REMARKS

By this amendment, the specification and claim 15 have been amended to correct typographical errors. The drawings have been amended for clarity. Claims 1 and 8 have been amended to more clearly define the invention claimed. Claims 2-7 have been cancelled. No new matter has been added. Claims 1 and 8-16 are now pending in the application.

Fig. 6a(1)

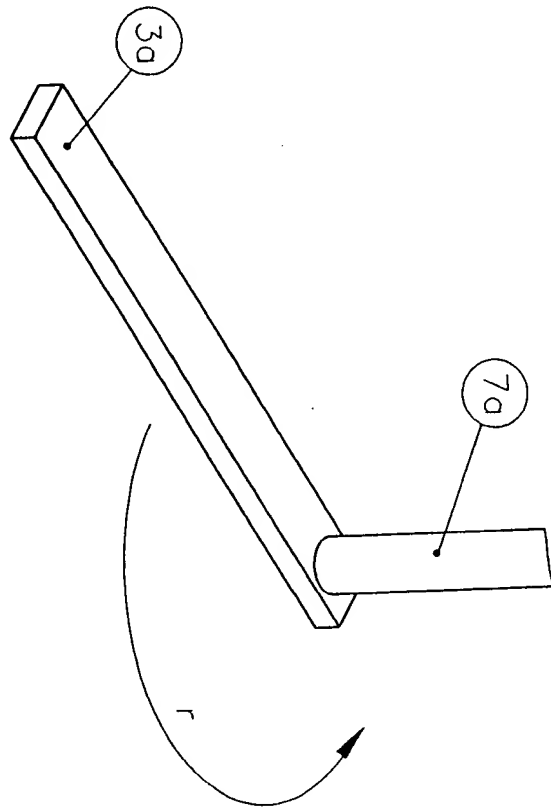
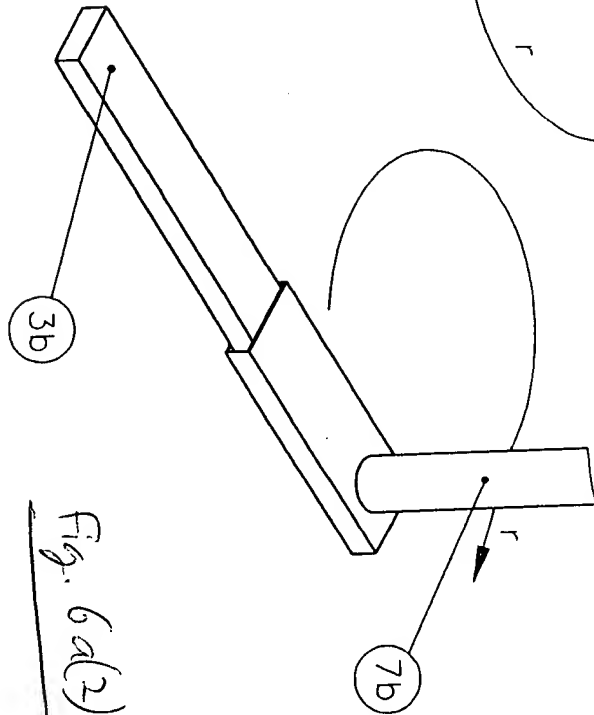
The Office objected to Figs. 6a, 6f, 7a, and 8 as improperly including two embodiments in a single figure. By this

amendment, Figs. 6a and 6f have been split into Figs. 6a(1) and 6a(2) and Figs. 6f(1) and 6f(2), respectively. The corresponding descriptive text of the specification has been properly amended to reflect this change.

~~(Amended) Fig. 6A~~
